Re: Durango Units 4&5 – Preliminary Plat and Infrastructure List Amendment (PR-2018-001996)

PRELIMINARY PLAT FOR
DURANGO UNITS 4 & 5
 UNIT 4 LOTS 1-20, UNIT 5 LOTS 1-19 & TRACT A
 CITY OF ALBUQUERQUE
 BERNILLO COUNTY, NEW MEXICO
 PROJECTED SECTION 16, T 11 N, R 2 E, NMPM
 TOWN OF ALAMEDA GRANT
 JULY 2019

AMENDED
 PRELIMINARY PLAT FOR
 DURANGO UNITS 4 & 5
 UNIT 4 LOTS 1-20, UNIT 5 LOTS 1-19 & TRACTS A&B
 CITY OF ALBUQUERQUE
 BERNILLO COUNTY, NEW MEXICO
 PROJECTED SECTION 16, T 11 N, R 2 E, NMPM
 TOWN OF ALAMEDA GRANT
 JULY 2020

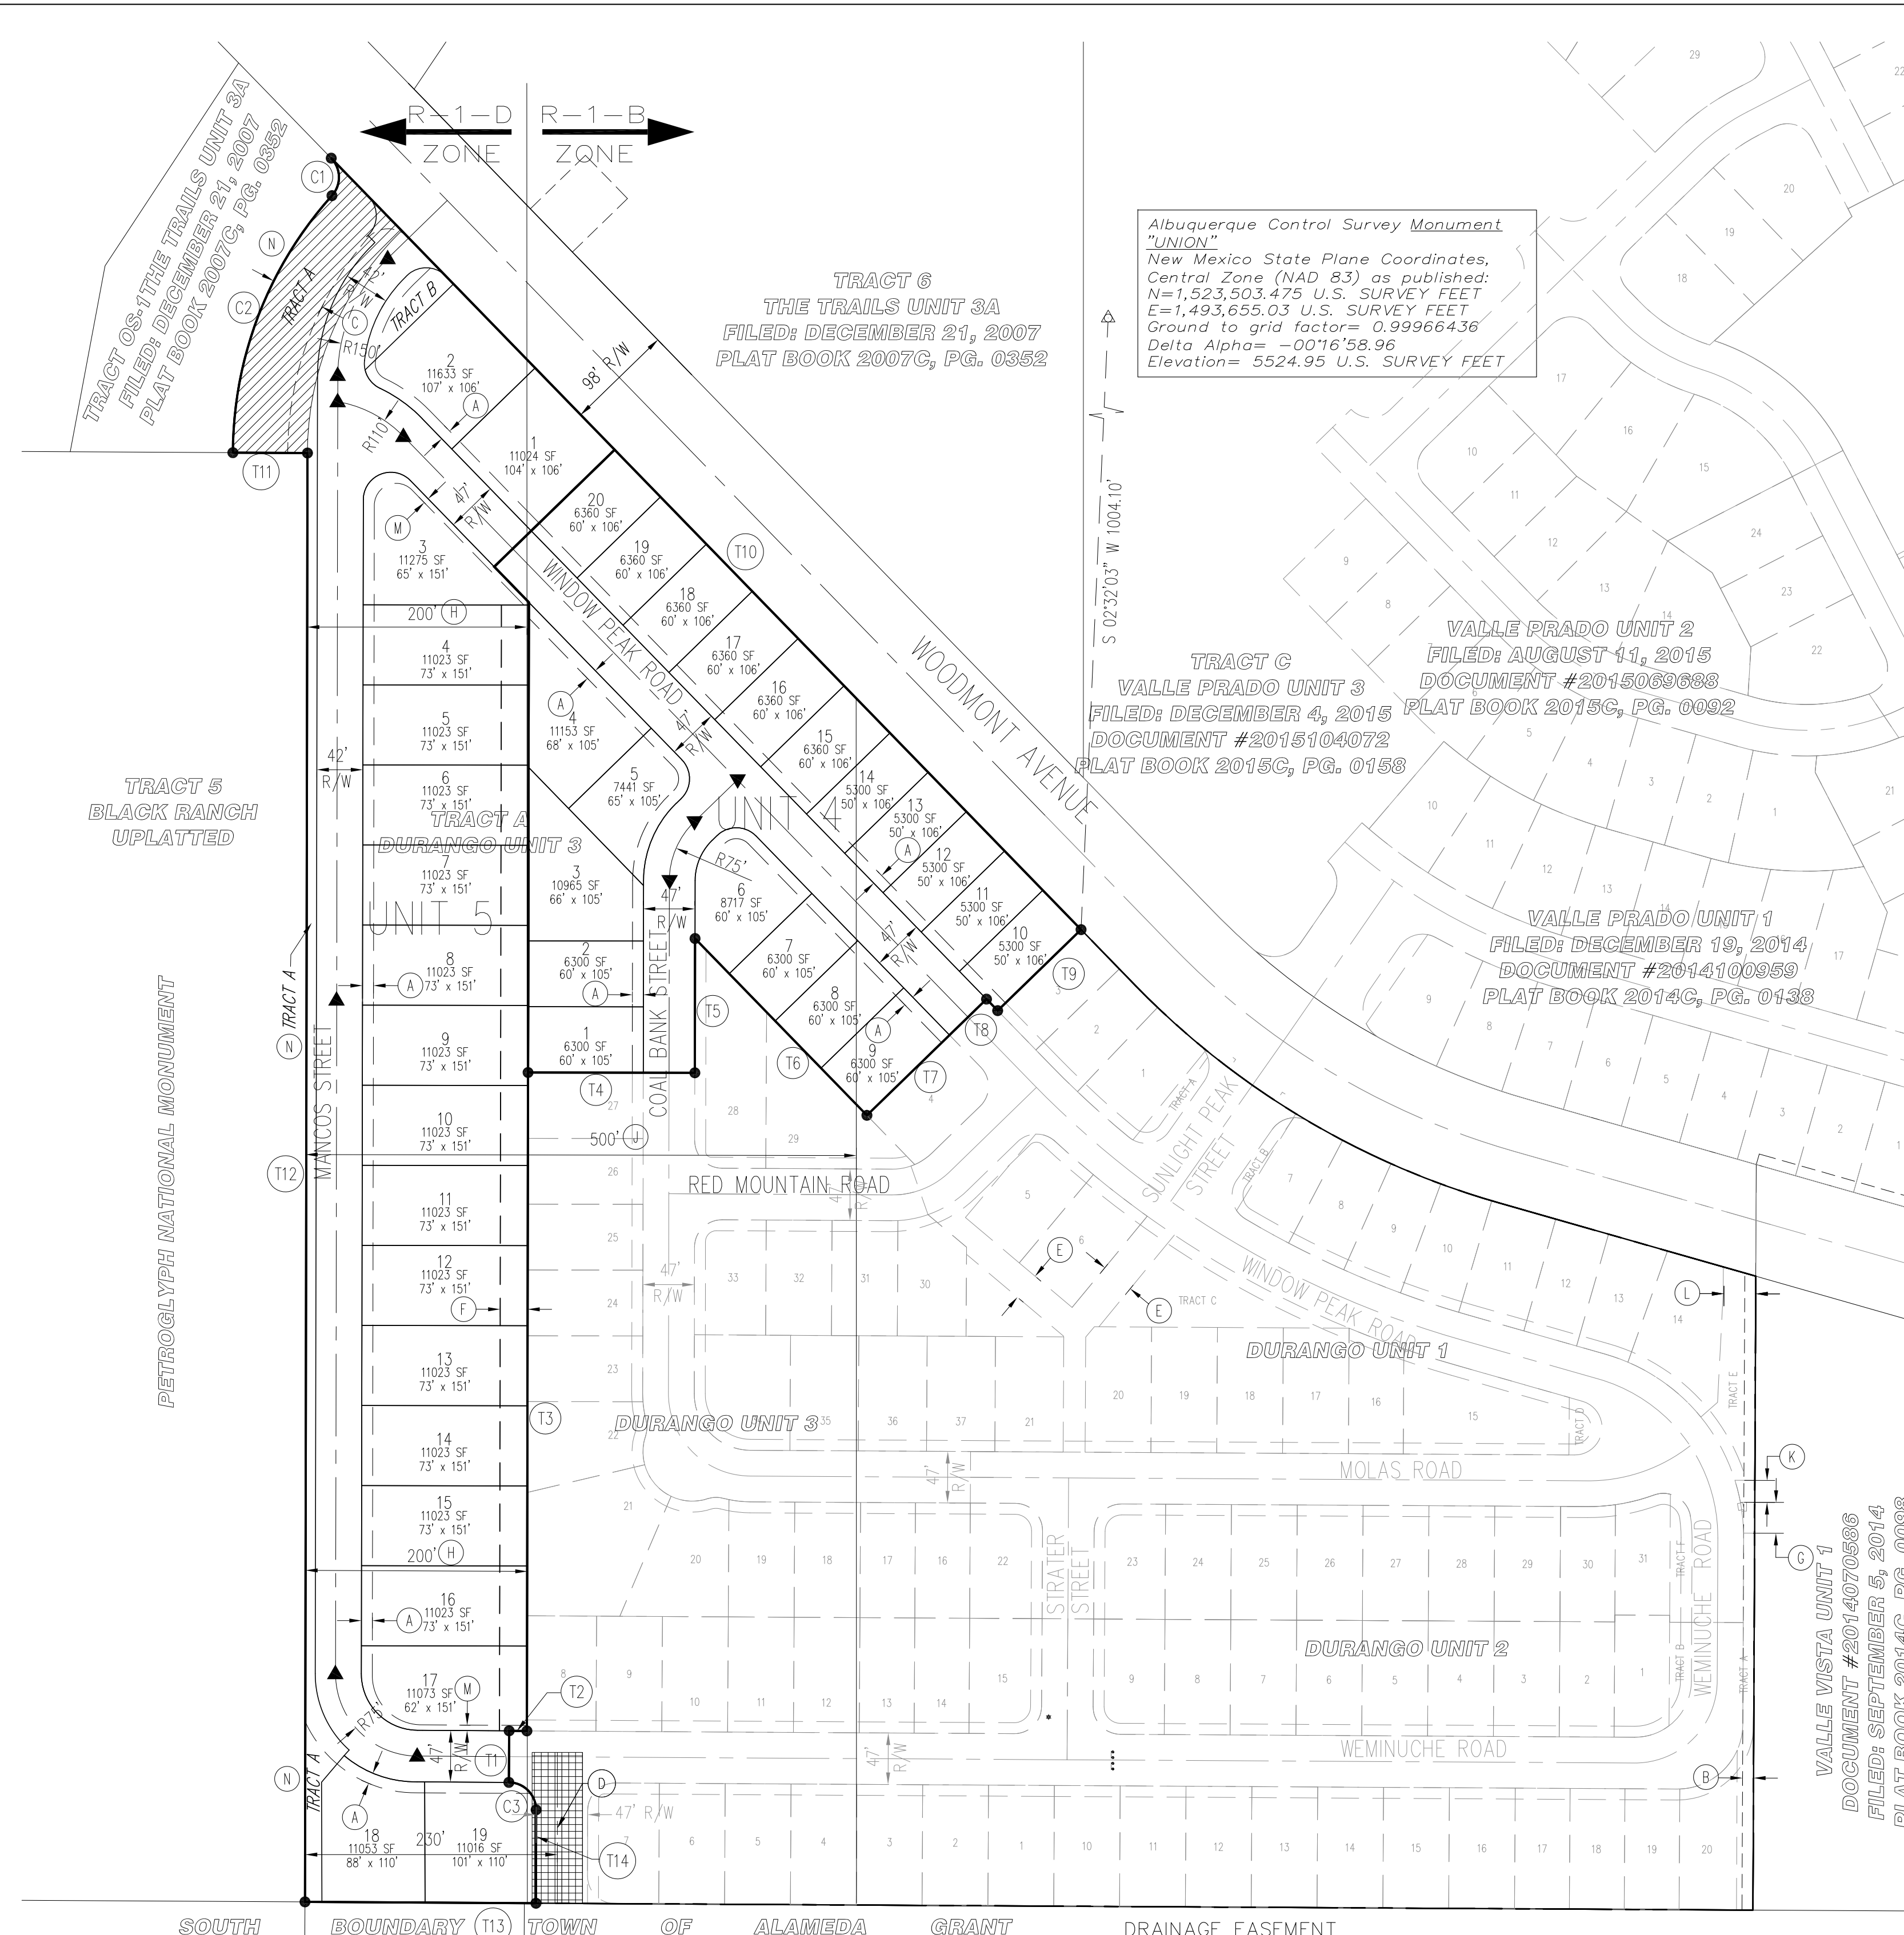
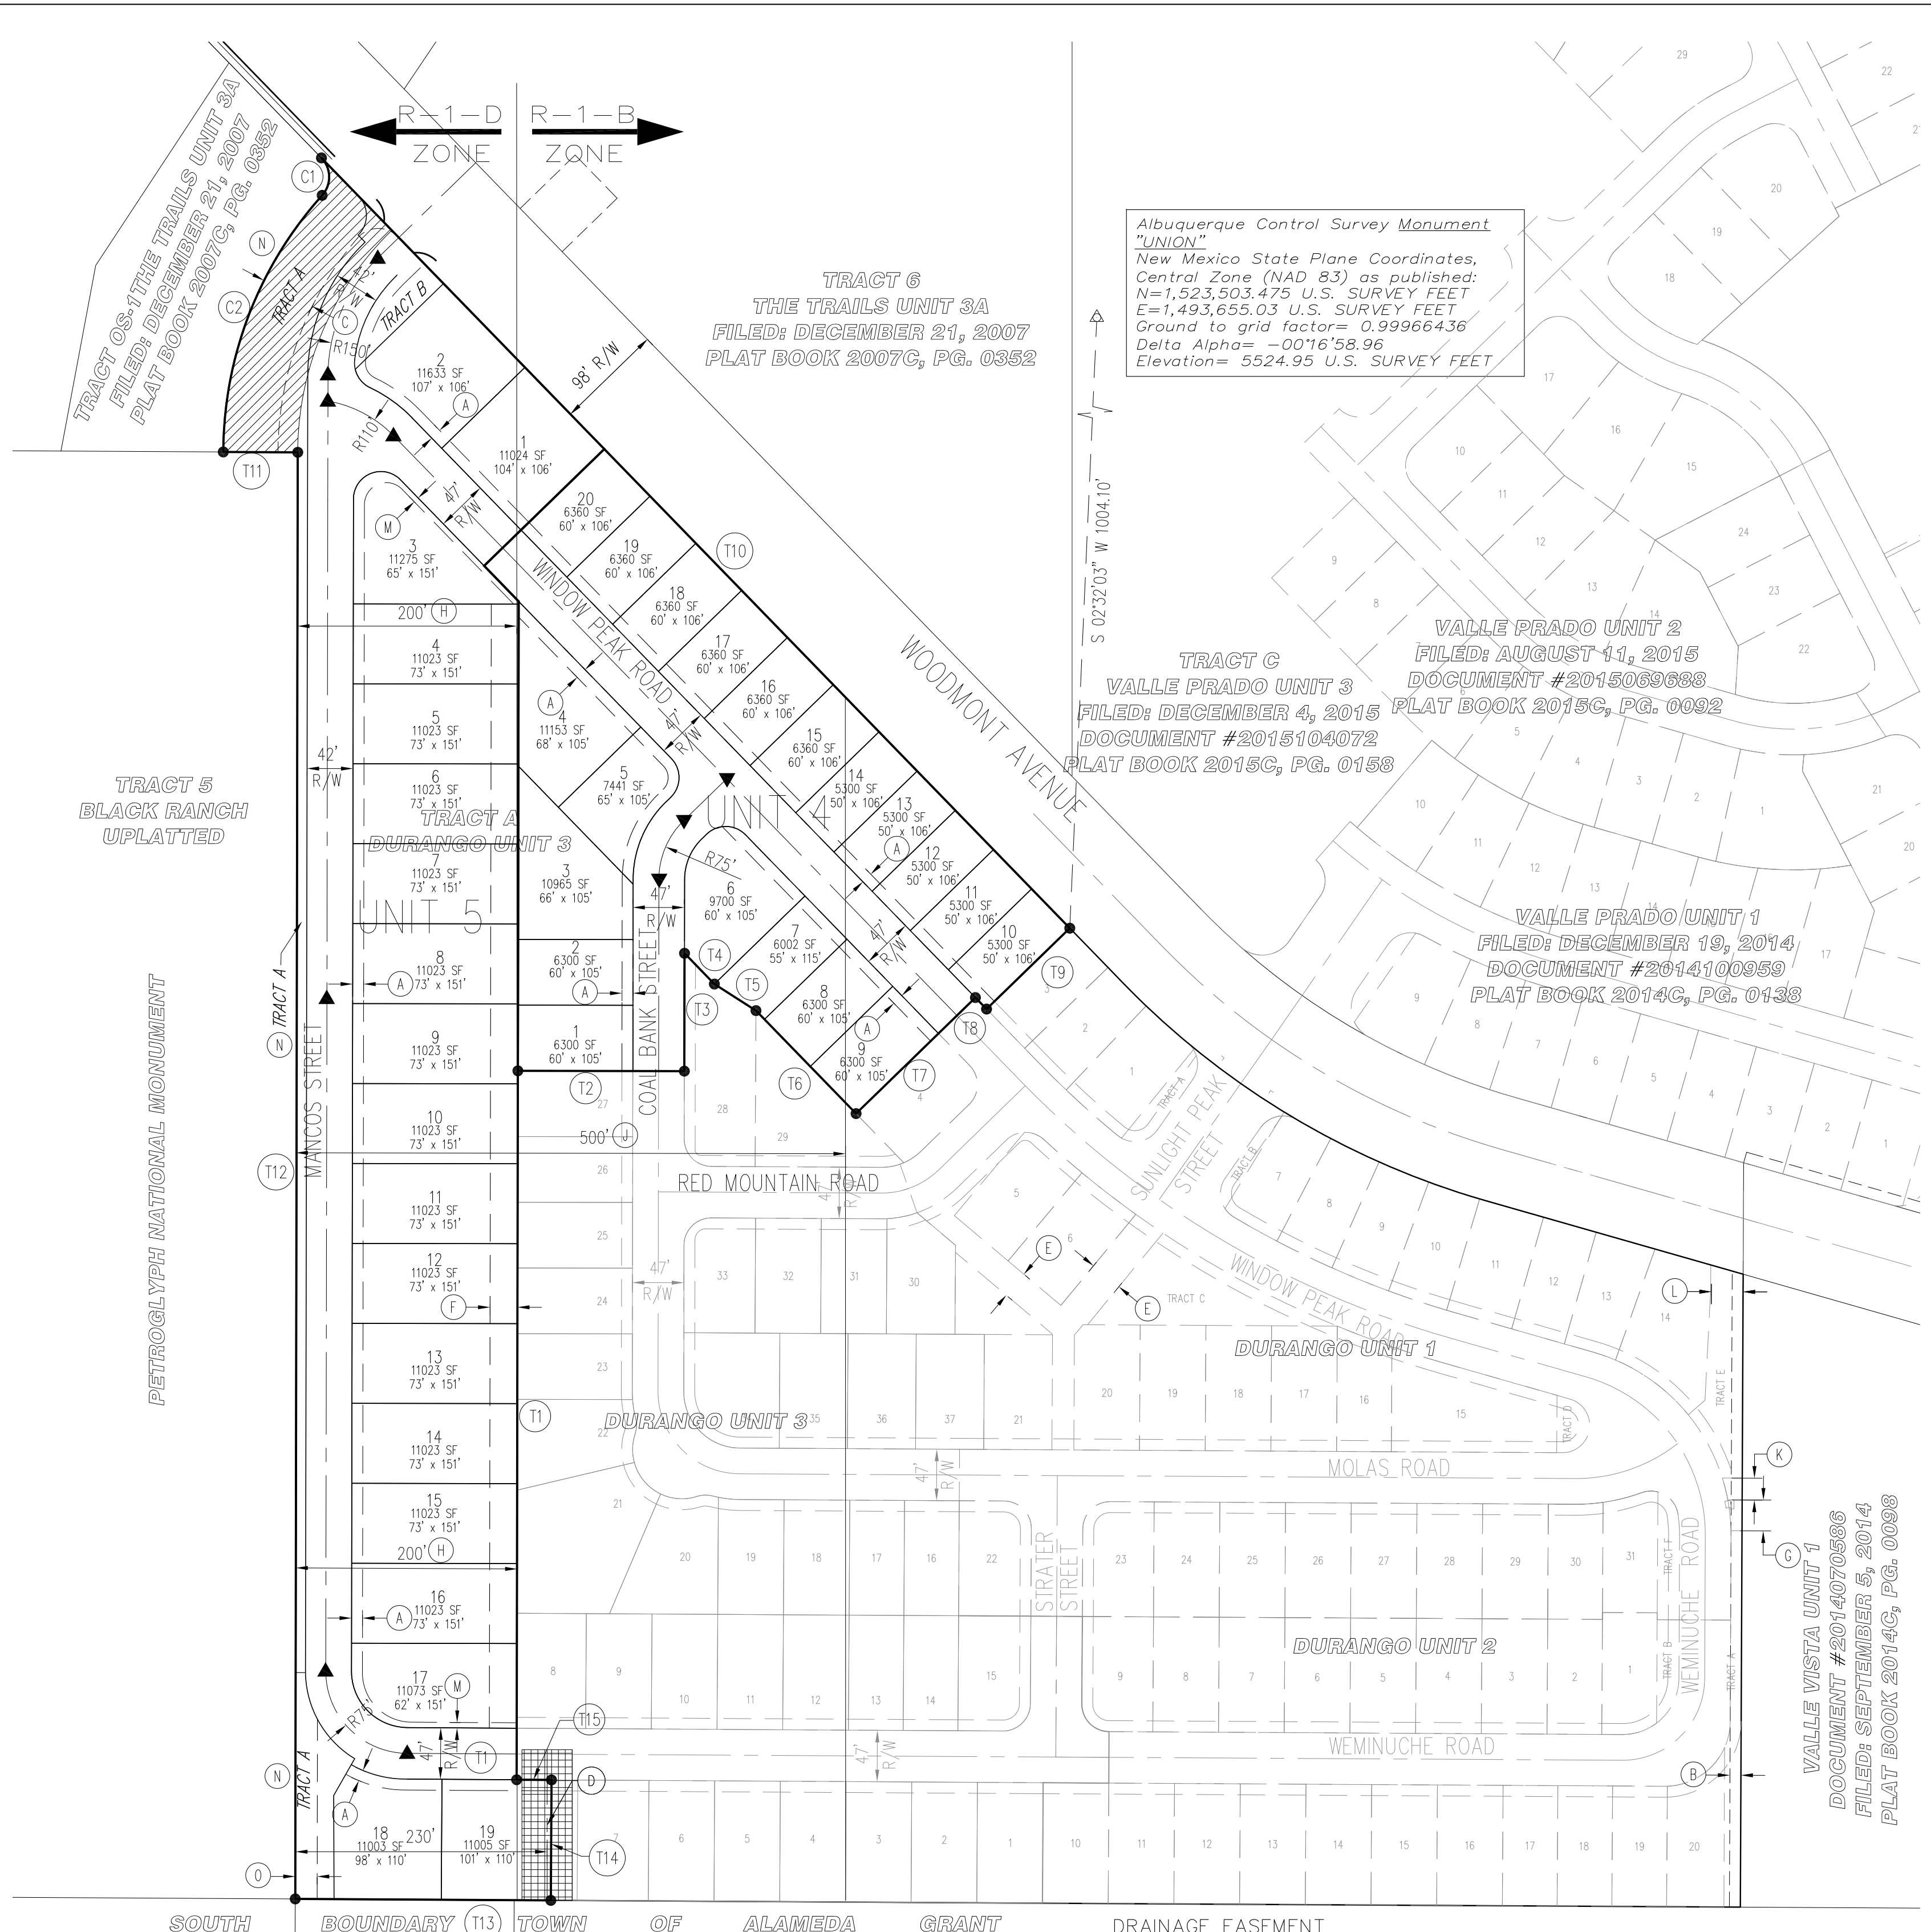
We are requesting an amendment to the existing Durango Units 4&5 preliminary plat and infrastructure list to reflect changes along Weminuche Road due to the removal of Hillerman Street from the Durango Unit 3 preliminary plat. The preliminary plat and infrastructure list were approved by the DRB on August 14, 2019.

Hillerman Street was going to have a waterline connection to the school site, but APS would not grant the necessary easement for the connection. In lieu of the Hillerman Street connection, the ABCWUA requested that we grant a 20' waterline easement within an HOA Tract along the Unit 5 west boundary for a future Zone 5W waterline connection. Unit 5 Lots 18 & 19 were shifted to the east to accommodate the 20' easement in the HOA Tract. The amended preliminary plat reflects the lot shift and 20' easement. The Unit 5 infrastructure list reflect the changes to the waterline infrastructure.

- (M) 5' PUBLIC UTILITY EASEMENT GRANTED BY PLAT.
- (N) BLANKET DRAINAGE EASEMENT ON TRACT A GRANTED TO THE TRAILS COMMUNITY ASSOCIATION, INC.
- (O) 20' PUBLIC WATERLINE EASEMENT GRANTED TO THE ABCWUA BY PLAT.
